SUNTERRA

FIRST AMENDMENT TO AMENDED AND RESTATED DESIGN GUIDELINES

Harris and Waller Counties, Texas

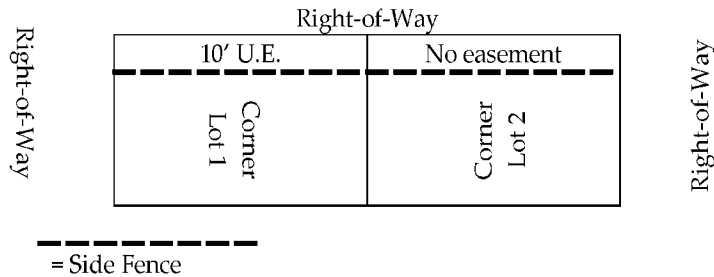
8. **3.7 Masonry Color Repetition.** Section 3.7 of the Amended and Restated Design Guidelines is hereby deleted in its entirety and replaced with the following:

A wide diversity of material types and colors is discouraged in favor of a more continuous theme creating a continuity of materials throughout the Community.

When considering repetition of masonry types and colors, one (1) Lot skip is required to use the same masonry color family (brown, gray, tan, white) on either side of the street, including painted brick.

EXHIBIT "1.2"

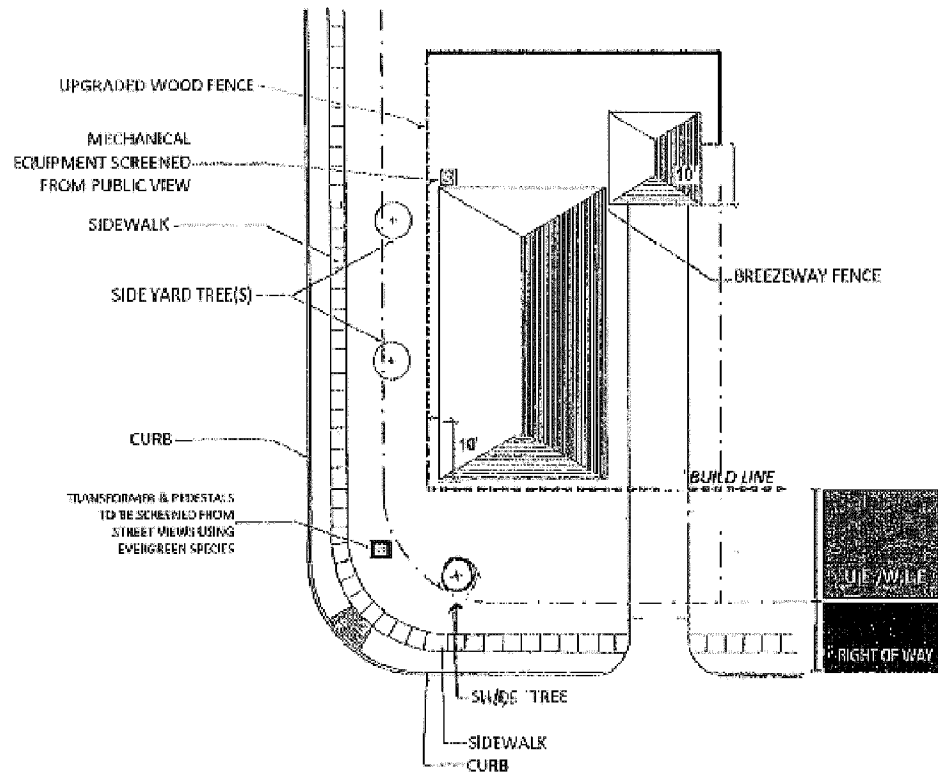
1. **Exhibit 1.2.** Exhibit 1.2 to the Amended and Restated Design Guidelines is hereby deleted in its entirety and replaced with a new Exhibit 1.2 attached hereto.

EXHIBIT "1.2.A"

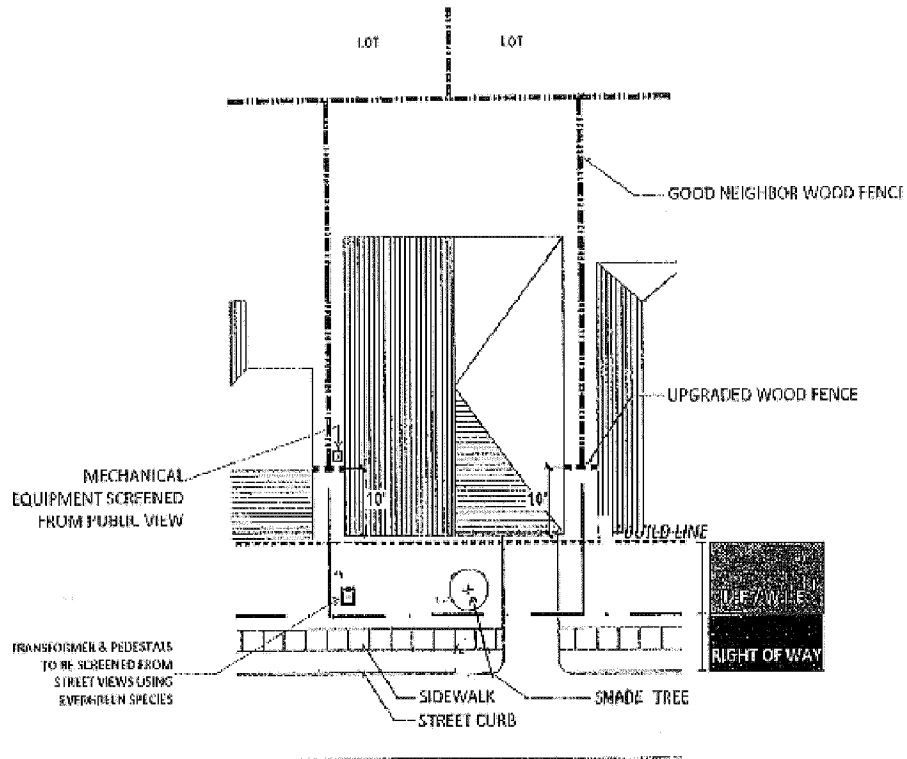
2. **Exhibit 1.2.A.** Exhibit 1.2.A to the Amended and Restated Design Guidelines is hereby deleted in its entirety and replaced with a new Exhibit 1.2.A attached hereto.

EXHIBIT "1.2.B"

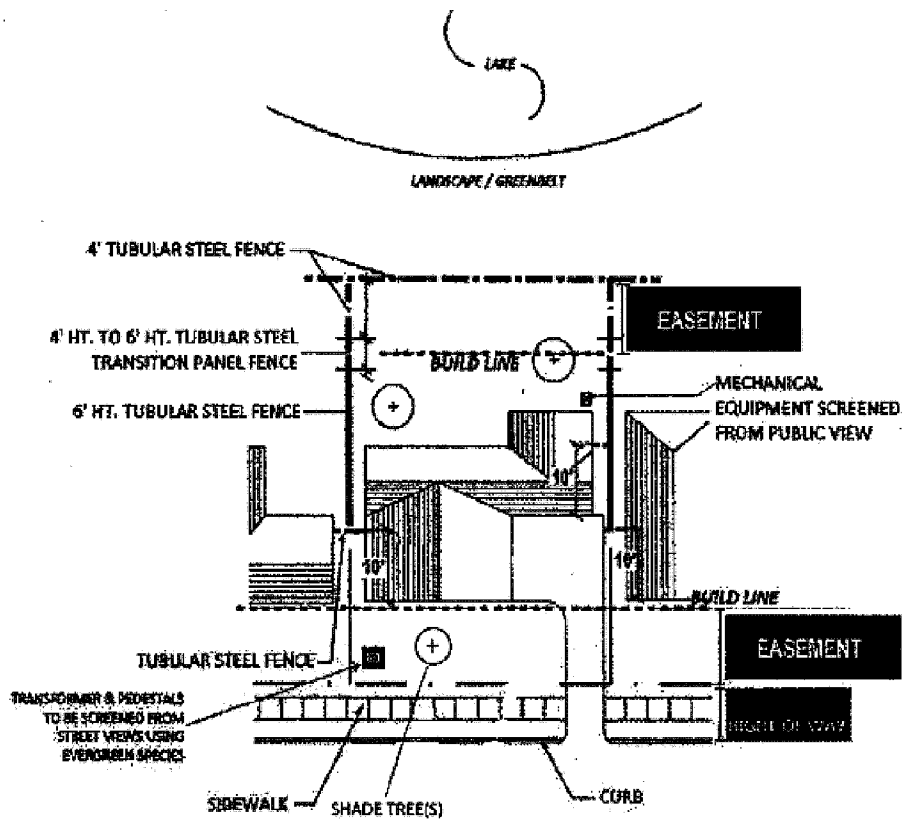
3. **Exhibit 1.2.B.** Exhibit 1.2.B to the Amended and Restated Design Guidelines is hereby deleted in its entirety and replaced with a new Exhibit 1.2.B attached hereto.

EXHIBIT 4.3

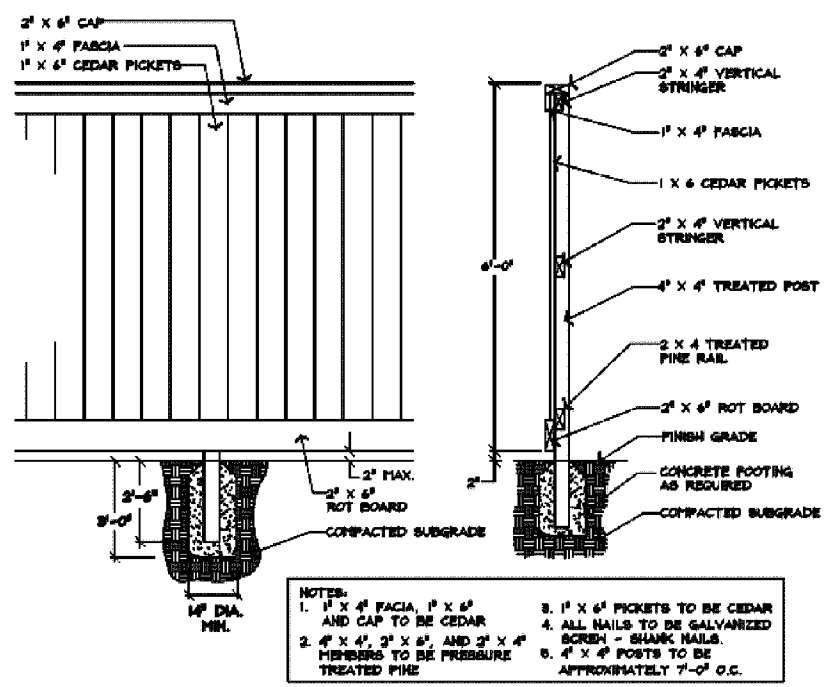
13. **Exhibit 4.3.** Exhibit 4.3 of the Amended and Restated Design Guidelines is hereby deleted in its entirety and replaced with a new Exhibit 4.3 attached hereto.
